Wilson Walk
208/210, 220, 230,
240 Wilson Street

A18
2 record of plan changes from march 14, 2019

Supplement Information

A08 Parkade Plan
1 scale: 1/8" = 1'-0"

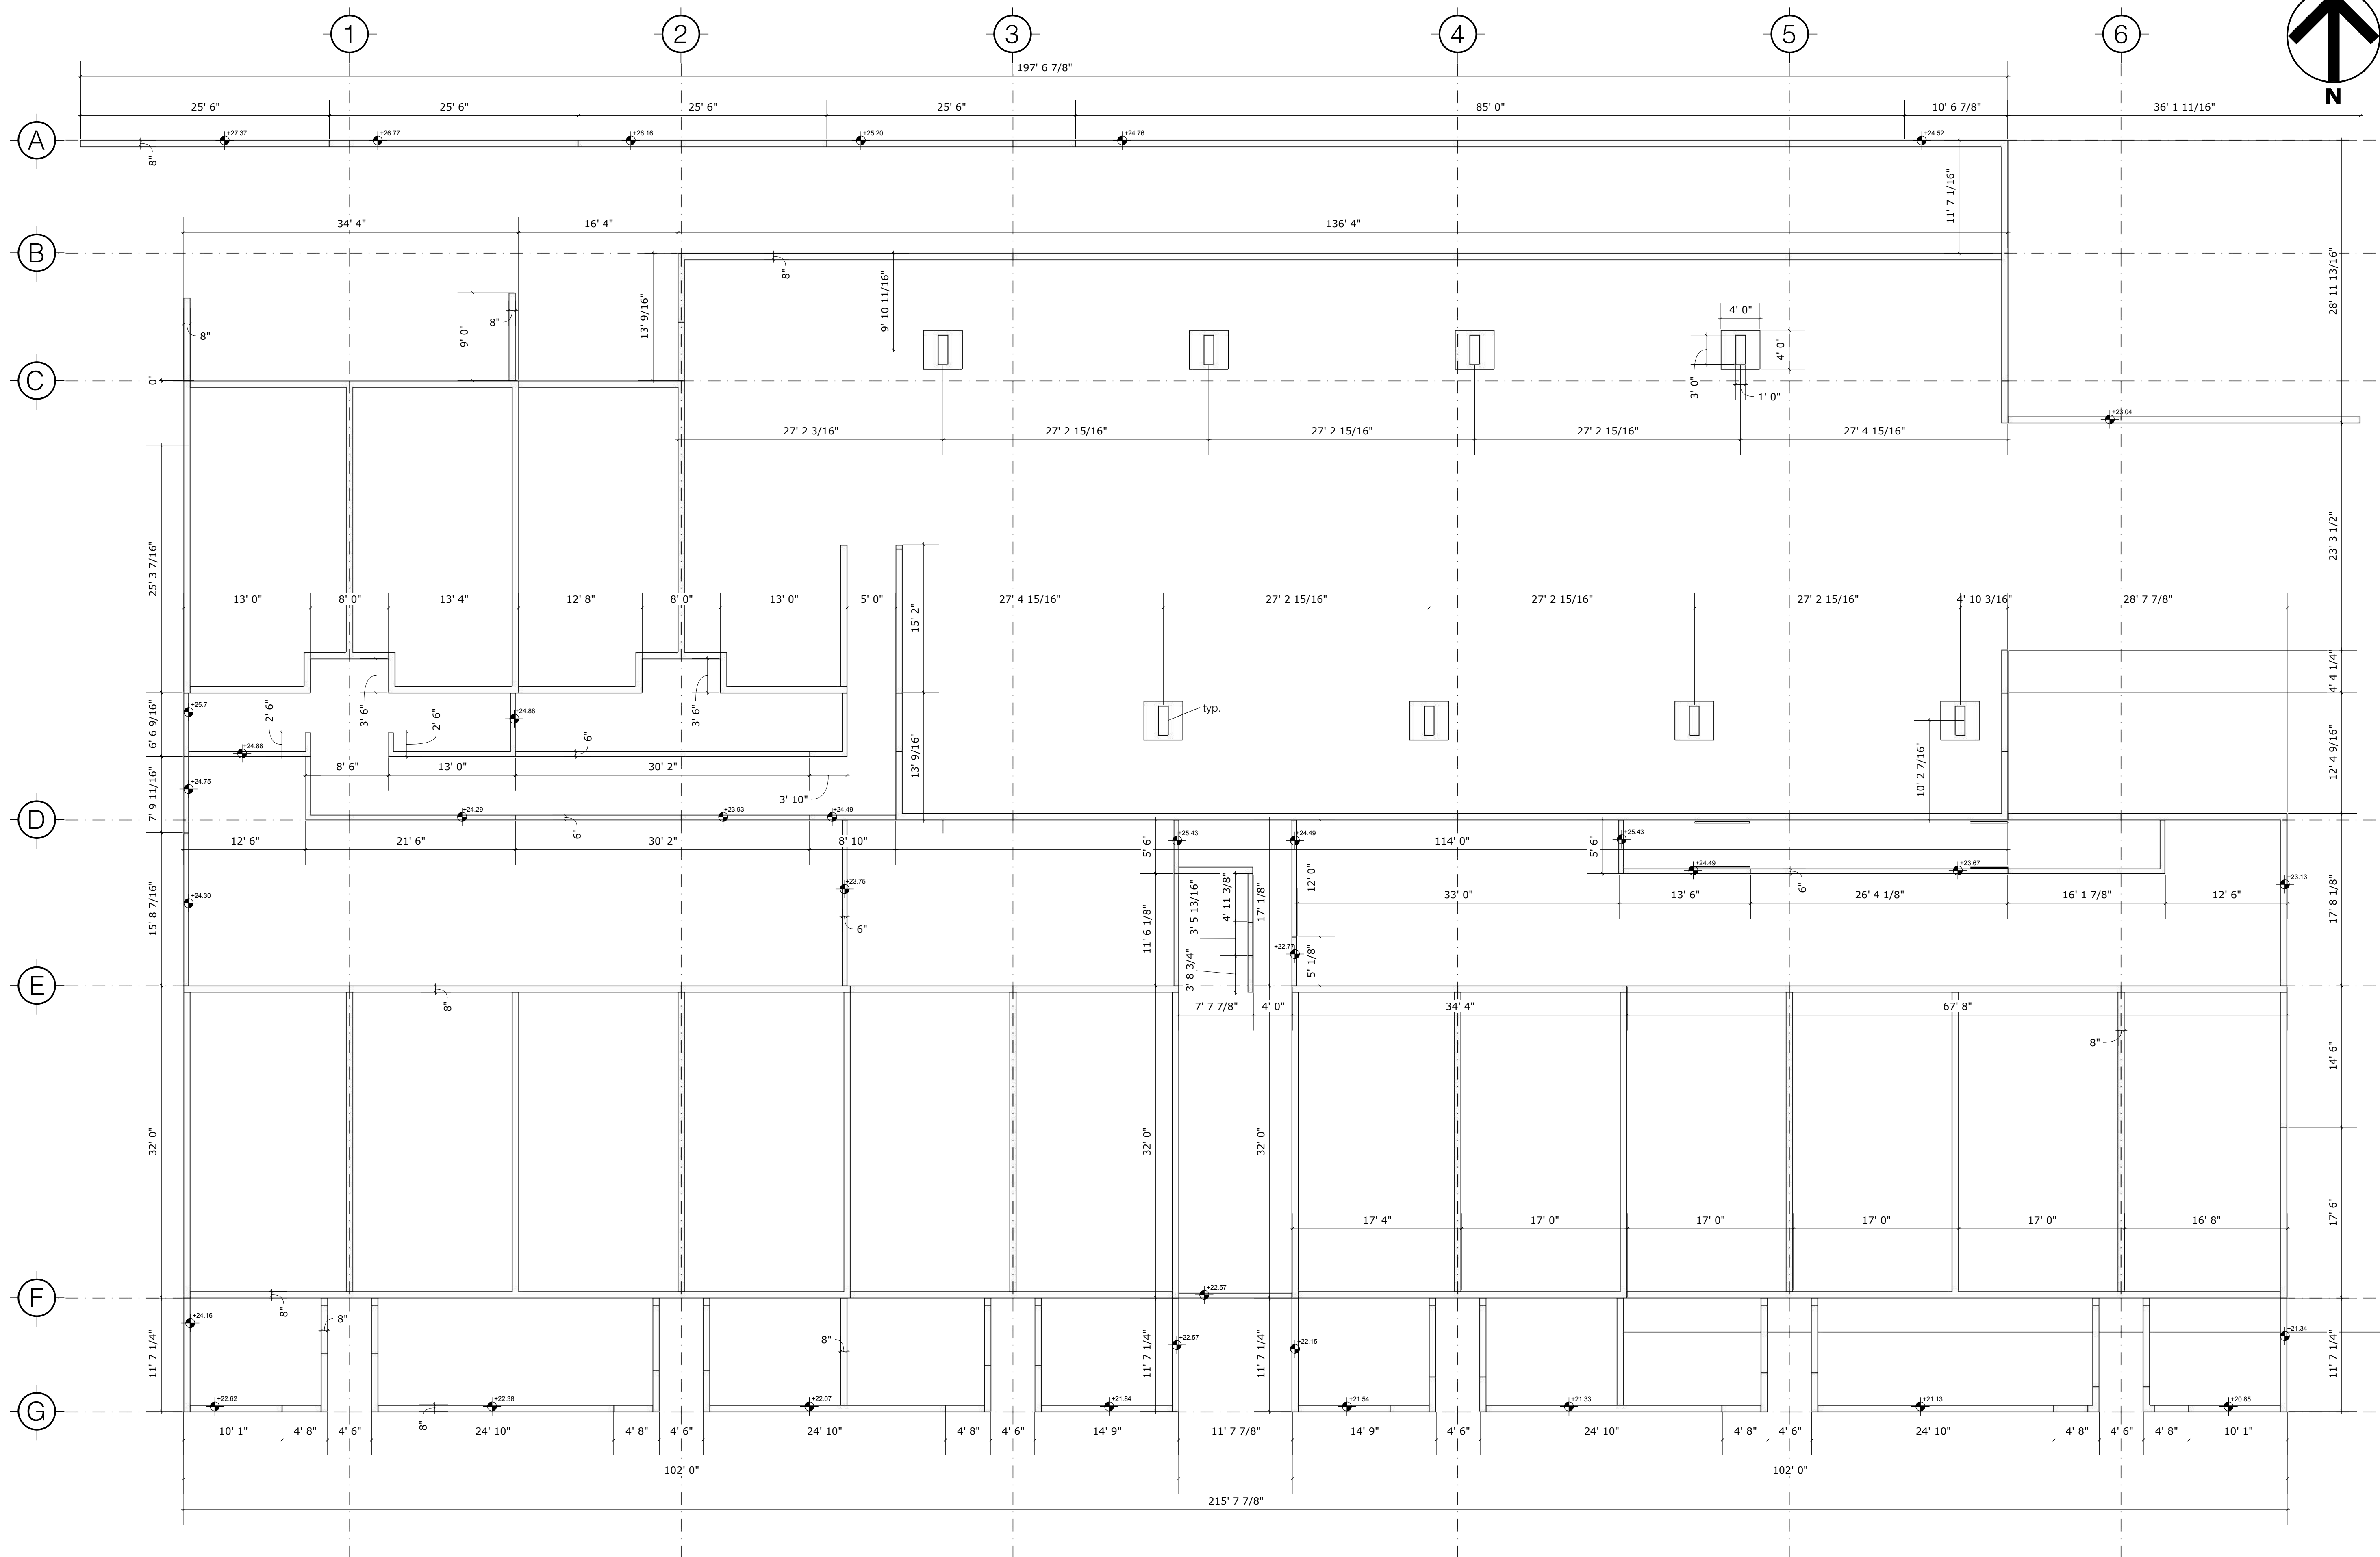
7	A08	door was removed and locking gate was introduced to increased ventilation as per consult with mechanical engineering. Total travel distances were re-calculated and are conforming to BCBC2018
8	A08	Gridlines were added to all floor plan layouts typ. to add clarity.
9	A08	example of Wilson Walk Project signage on East side of north building to add further clarity to that building face given questions brought up during ADP review.
10	A10	units 29-34 main floor elevation was raised to allow for better clearance/access into parkade. Jim requested that we allow for any possible increase that could be required given structrual engineering requirements at this stage rather than later so we have.
11	A11	units 29-34 upper floor elevation was raised to allow for better clearance/access into parkade. Jim requested that we allow for any possible increase that could be required given structrual engineering requirements at this stage rather than later so we have

A12 Roof Plan- see legend below
1 scale: 1/8" = 1'-0"

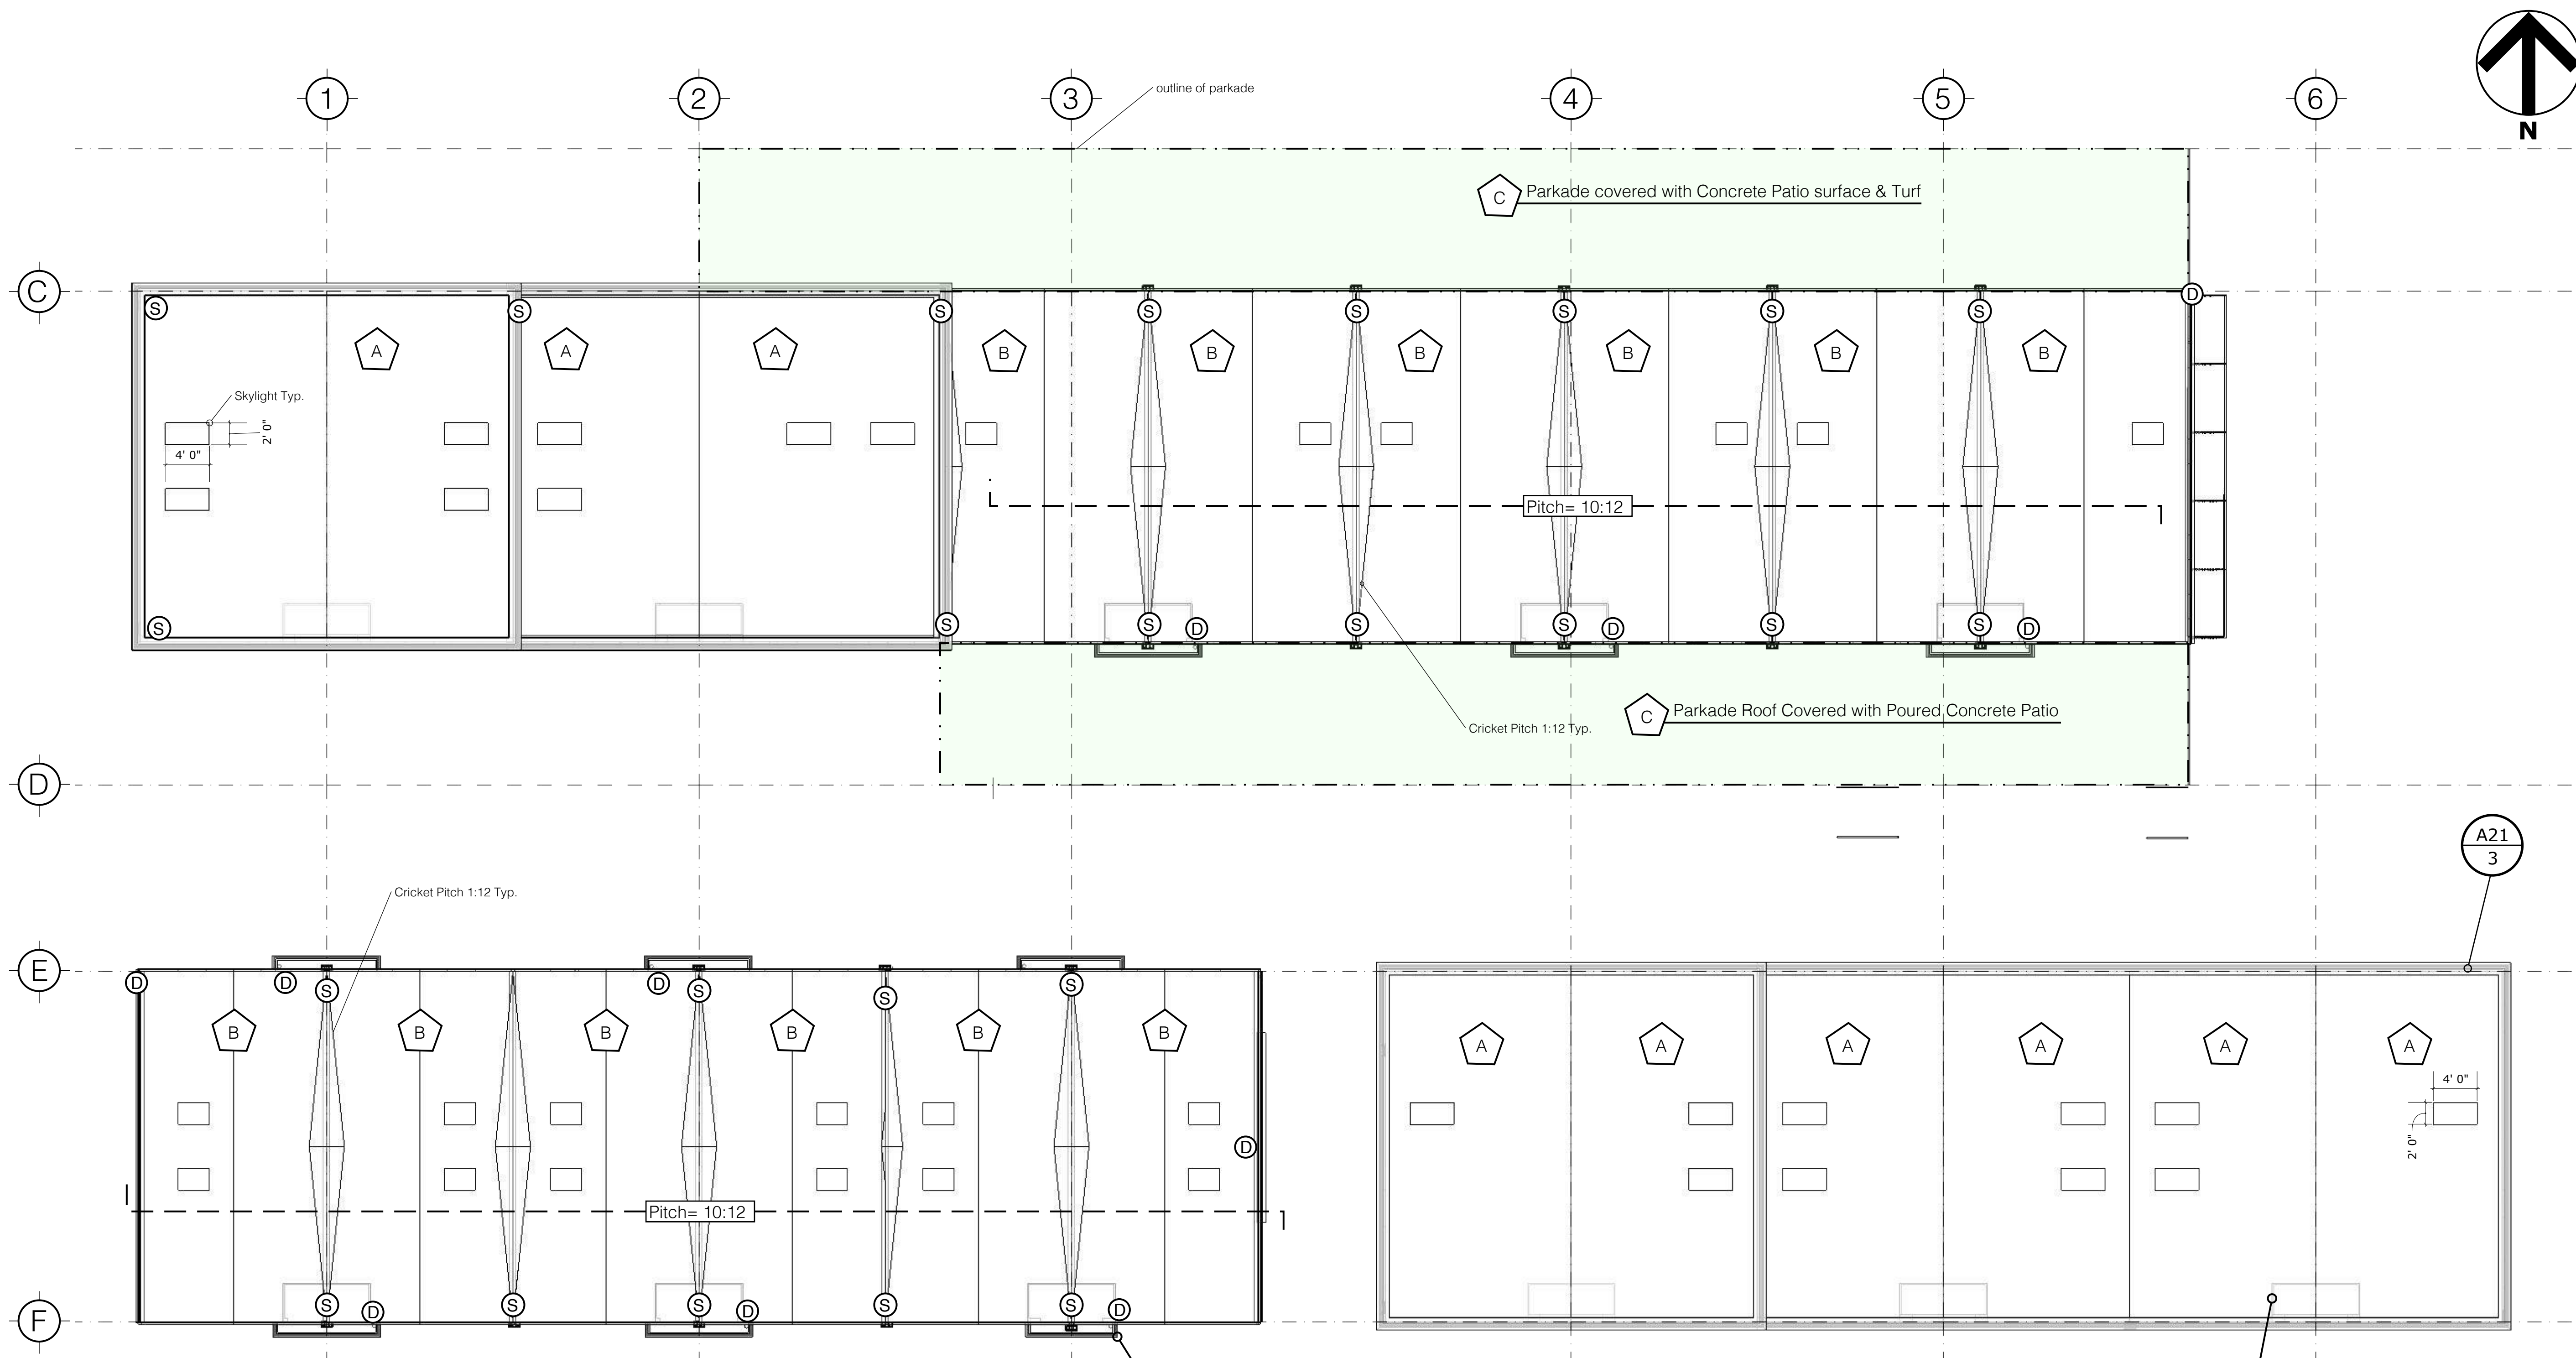
12	A12	roof pitch was changed from 12:12 to 10:12 to keep height of building consistent from what was shown previously given the requirement to raise both the main and upper floors to create better parkade headroom clearance at entry door.
13	A17	changes to height calculations and floor elevations as per above revisions 10 & 11
14	A18	Detail 3 was updated to show how we are complying with drive aisle slope % max as per parking bylaw.
15	A20	dimensions were added in parkade cross sections to better show that we are meeting our 2.1m height clearance requirement. The engineers and architect are well aware of the head clearance requirements and we are and conforming.
16	A22	added detail for front entry stairs from south building leading to sidewalk on Wilson as per feedback from ADP review. Spindle change, dimensions, profiled top cap, return at bottom of stairs and eased transitions.
